COMAL COUNTY
ENGINEER'S OFFICE

**Permit of Authorization to Construct an On-Site Sewage Facility
Permit Valid For One Year From Date Issued**

Permit Number: 116752
Issued This Date: 03/04/2024
This permit is hereby given to: James Barker

1518 OAK MEADOWS
CANYON LAKE, TX 78133

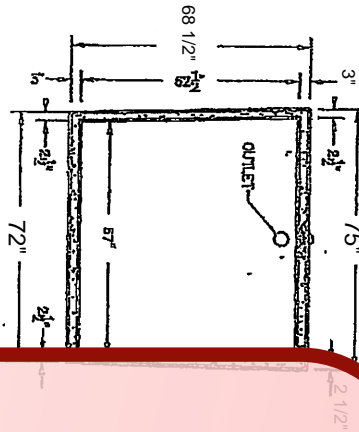
- 3. System Summary Section:
 - a. There seems to be a discrepancy:
 - ✓ In one area, you mention 2 spray heads, while in another, it's 3 spray heads.
 - ✓ The site plan depicts 3 spray heads. Clarification is needed.

- 4. Include the 30 TAC 285.38 rules in the planning materials:
 - ✓ Attached are the new rules, effective from September 1, 2023.
- 5. Site Plan:
 - ✓ Please display the contours.

- ✓ What is the slope from the Structures/RVs to the Treatment components?
- 6. Special Conditions for this Permit:
 - ✓ Ensure the following conditions are incorporated into the planning materials.
